GOVERNMENT OF THE DISTRICT OF COLUMBIA
DEPARTMENT OF TRANSPORTATION

MEMORANDUM

DATE: March 25, 2016

SUBJECT: ZC Case No. 15-13 – Watkins Alley 1311 E Street, SE

Figure 1 - Site Access Plan (Source: Well & Associates)

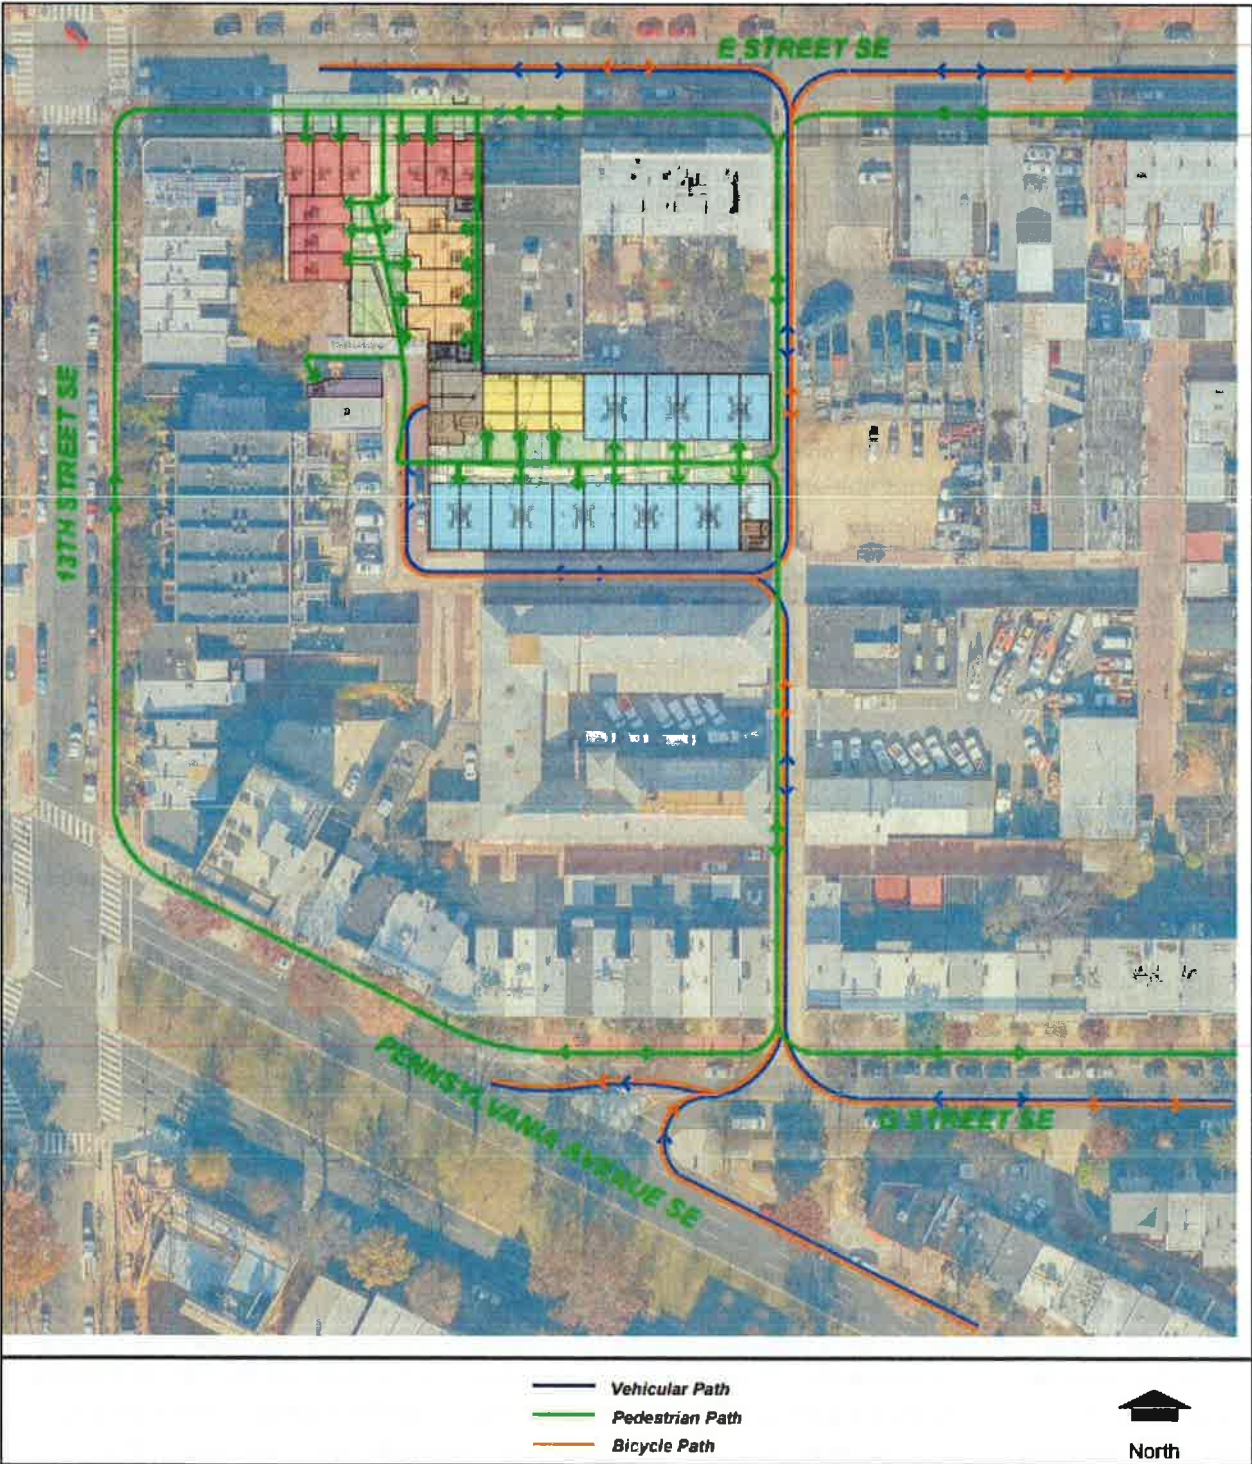
Vehicle and bicycle site access is proposed from the dead-ended north-south alley public alley along the western edge of the site. The Applicant proposes internal courtyards for pedestrian circulation through the site that can be accessed via E Street and the north-south public alley to the east of the site. Multi-modal site access diagrams are shown in Figure 1.

It is expected that the proposed development will increase the amount of pedestrians using the public alley to access transit and other destinations. During the public space permitting process, the Applicant may be expected to provide safety mitigations such as signage or pavement markings through the alley system to better manage potential pedestrian and vehicle conflicts. Such improvements would need to be coordinated with other developments near the site.
